Application for Licence Amendment

Licence Number	L5529/1988/12
Licence Holder	Mt Magnet Gold Pty Ltd
ACN	008 669 556
File Number	DER2016/001228-1
Premises	Mt Magnet Gold MOUNT MAGNET WA 6623 M58/30, M58/121, M58/136, M58/172, M58/181, M58/185, M58/187, M58/191, M58/193, M58/202, M58/205 and M58/234
Date of Report	22 December 2021
Decision	Revised licence granted

Licence L5529/1988/12 is held by Mt Magnet Gold Pty Ltd (Licence Holder) for Mt Magnet Gold (the Premises), located within multiple mining tenements. This Amendment Report documents the assessment of potential risks to the environment and public health from proposed changes to the emissions and discharges during the operation of the Premises. As a result of this assessment, Revised Licence L5529/1988/12 has been granted.

Figure 2: Distance to sensitive receptors

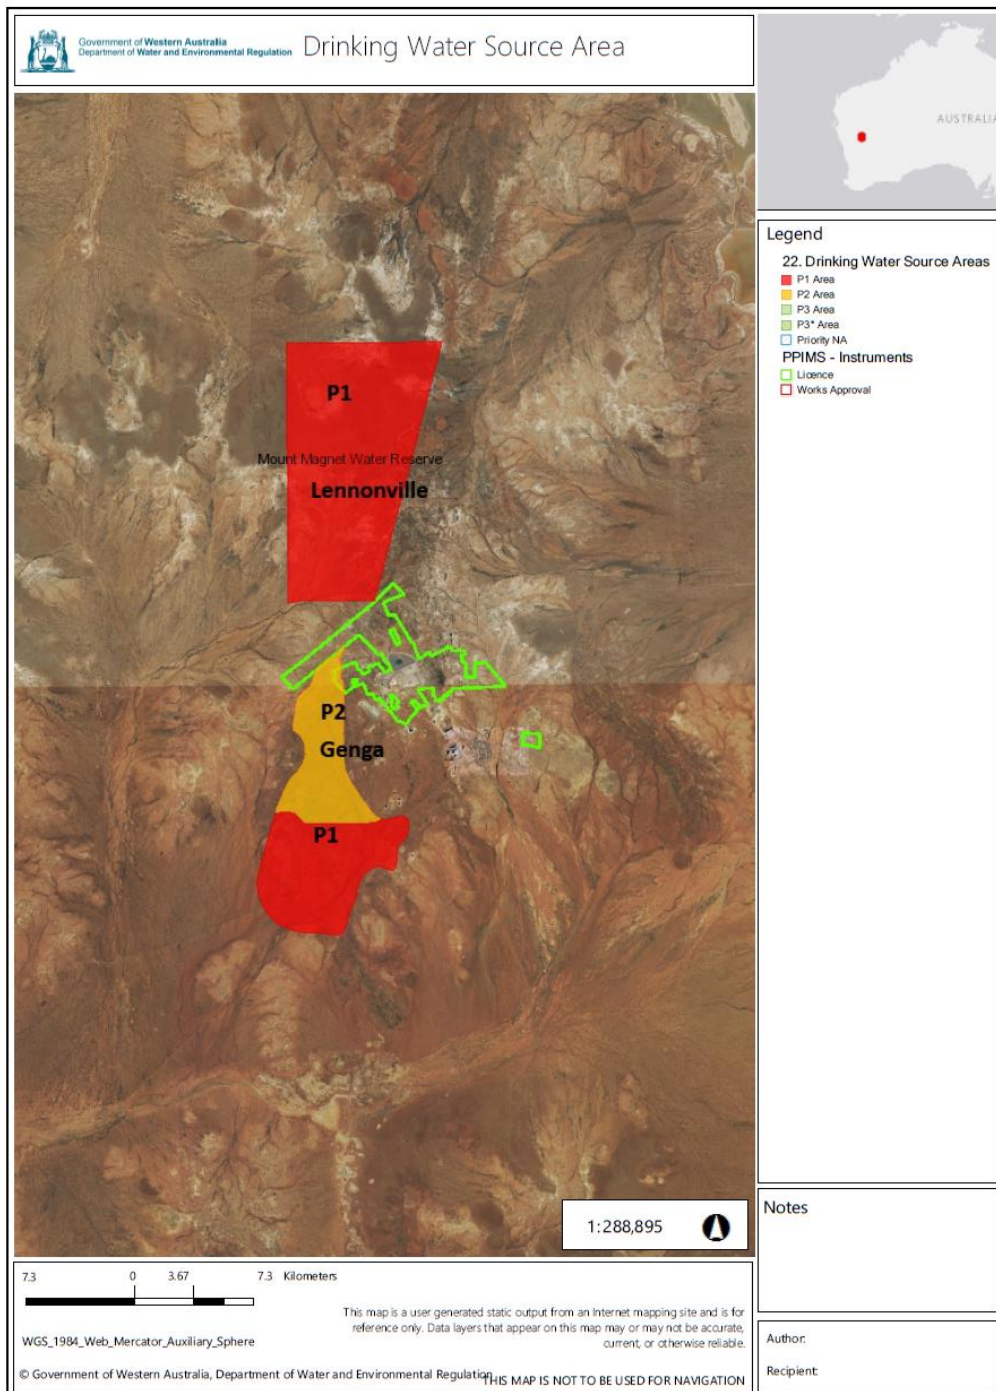
The Mount Magnet Water Reserve is a PDWSA, proclaimed under the Country Areas Water Supply Act 1947 (*CAWS Act*) and consists of the Genga and Lennonville water reserves. The premises partially lies within the Genga water reserve to the west, and borders on the Lennonville water reserve on the northern boundary (Figure 2)

The original application documentation for works approval W6342/2020/1 refers to seepage being 'permanently contained by the Galaxy complex pits', no confirmation or assessments to investigate these assumptions were provided. The applicant continues to maintain that these pits act as a sink for seepage.

Figure 3 Salinity (mg/L) recorded as TDS in selected monitoring bores

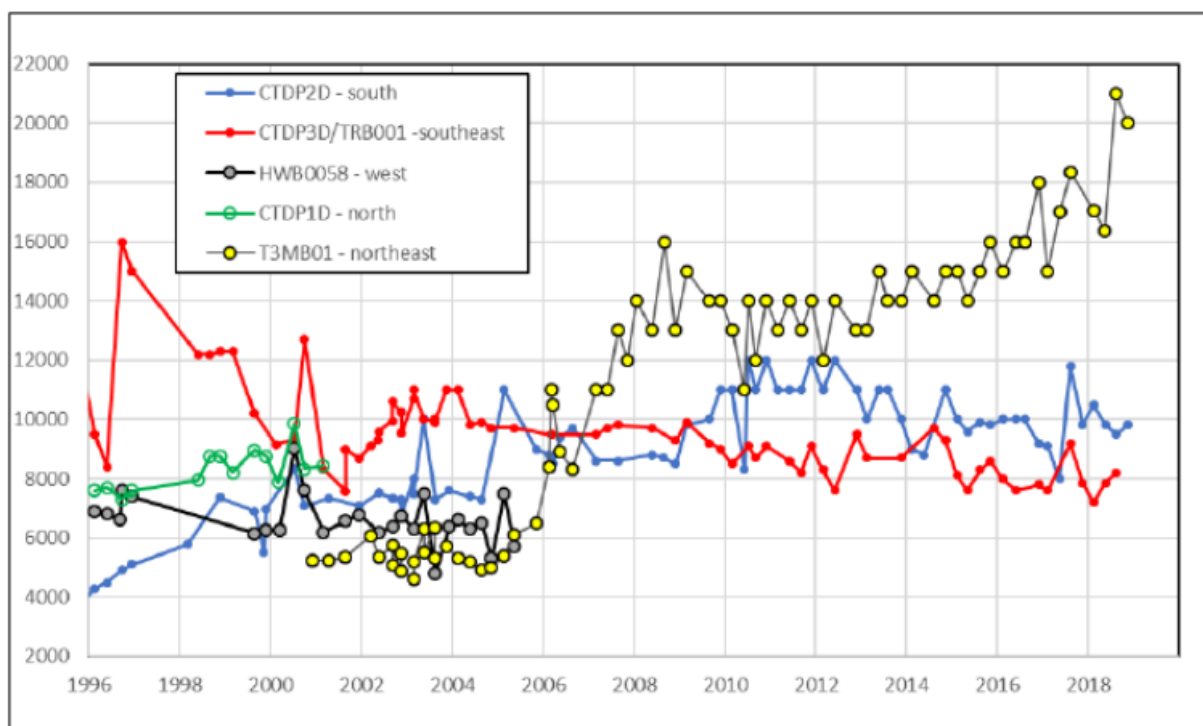
No tailings have been deposited into CTSF1 and CTSF2 since 2000 and 2001, respectively¹. Previous operations of CTSF1 and CTSF2 have resulted in high rates of seepage. Baseline water levels prior to development were recorded between 34 and 62 metres below ground level. The water level below CTSF1 and CTSF2 rose to the natural surface within 12 months of commencing operations (MWES, 2019). Historical data indicated multiple bores were detecting seepage from CTSF1 and CTSF2 during operations. CTDP1D, CTDP2D and HCB058 showed increased salinity and detectable cyanide, directly linked to tailings seepage impacts. Salinity levels of selected monitoring bores recorded are shown in Figure 3. For context, the local baseline groundwater salinity is approximately 4000 mg/L TDS.

Figure 4 Well locations in relation to electromagnetic survey

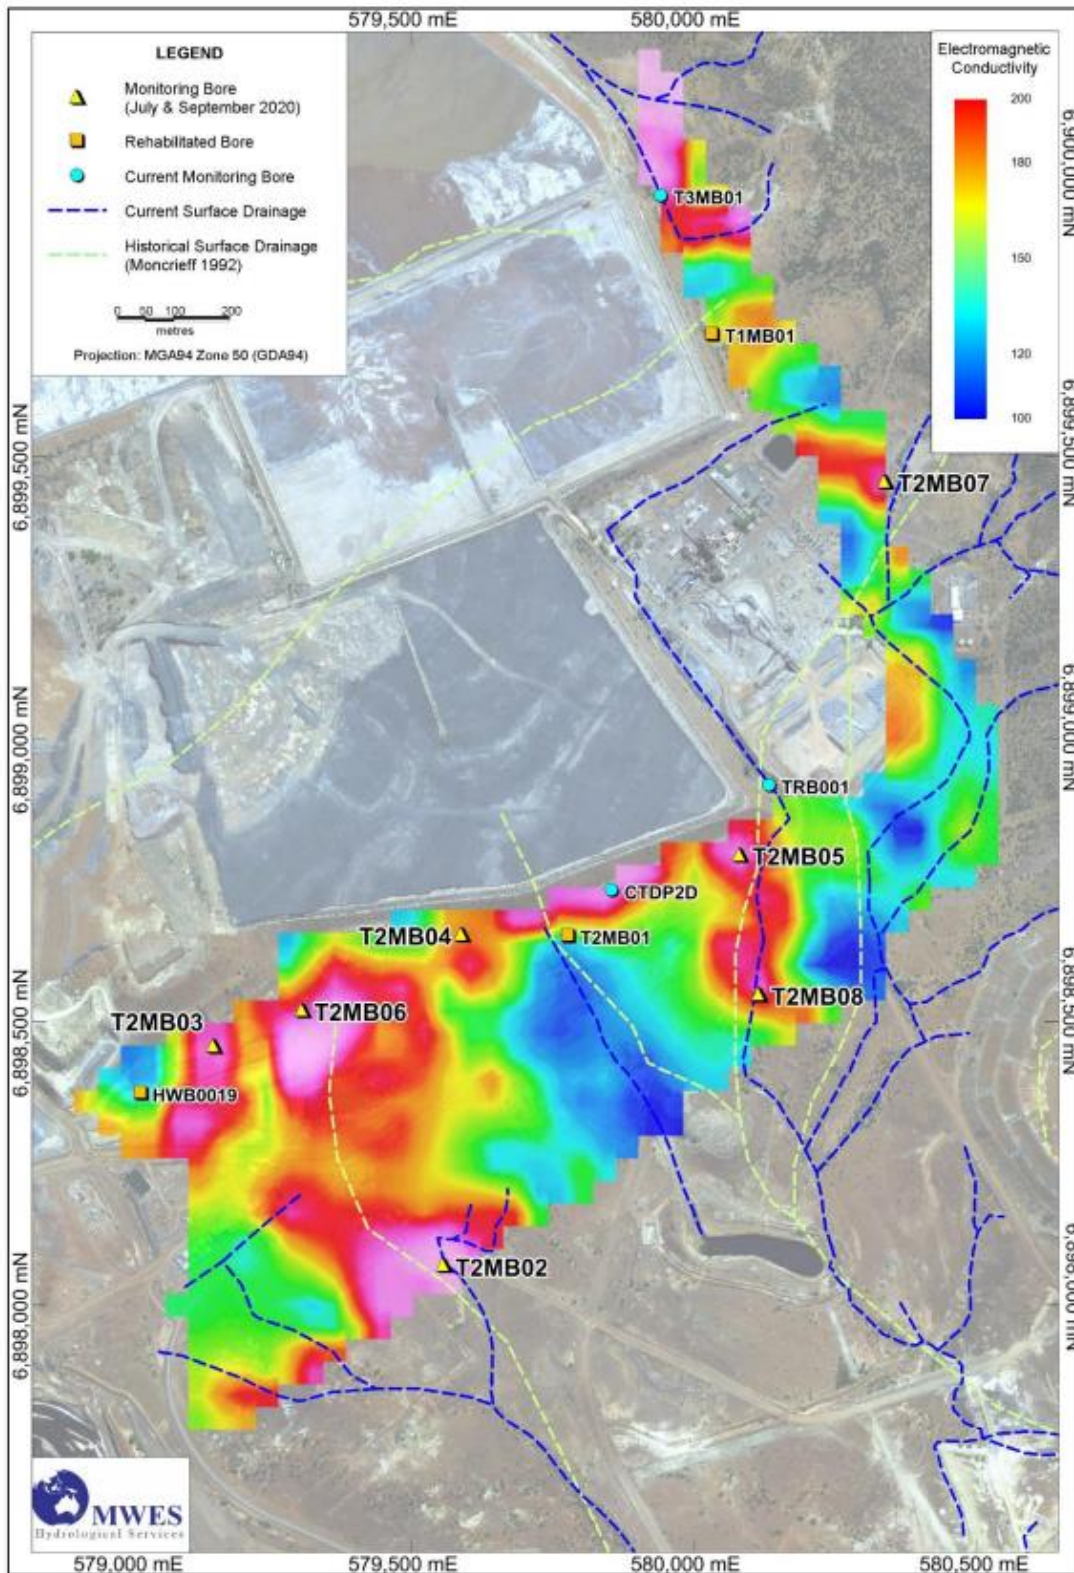
Principal Hydrogeologist suggested the contaminant/seepage plume may be moving at the base of the regolith, along the surface of fresh bedrock. Seven monitoring bores, T2MB02 – T2MB08, were drilled along seepage paths assumed from an electromagnetic (EM) survey (Figure 4). T2MB09 was installed on the western side of the Galaxy pits, to monitor for potential impacts to the nearby PDSWA (Figure 1).

MWES (2020) states that “well screens were placed against target aquifers... no perched aquifers, requiring separate shallow monitoring bores were encountered at any location” and that the new bores were screened at intervals from the base of the clay zone (part of the weathered regolith) to several metres into fresh rock (Table 5).

It is noted in borelogs for T2MB02 – T2MB08 that the monitoring wells have been screened across the weathered regolith/fresh rock interface. T2MB09 (on the western side of the Galaxy Pits, closest to the PDSWA) encountered water at 84.89m bgl and is screened from 82 – 100mbgl rather than at the clay/fresh rock interface (22m bgl - Table 5). There is consequently some uncertainty regarding whether T2MB09 has been appropriately screened. DWER will investigate this further and if required, a DWER initiated amendment will be undertaken.

Eight additional groundwater monitoring bores were consequently installed and more appropriately screened and located to detect seepage from CTSF1 and CTSF2. Monitoring was conducted monthly for 15 months, and concentrations for analytes of concern were found to be low, and within conservatively adopted 2021 Australian Drinking Water Guidelines for monitoring bore T2MB09 closest to the PDWSAs. Whilst some uncertainty exists regarding the appropriate screening of the T2MB09, borelogs indicated that a perched aquifer was not encountered.
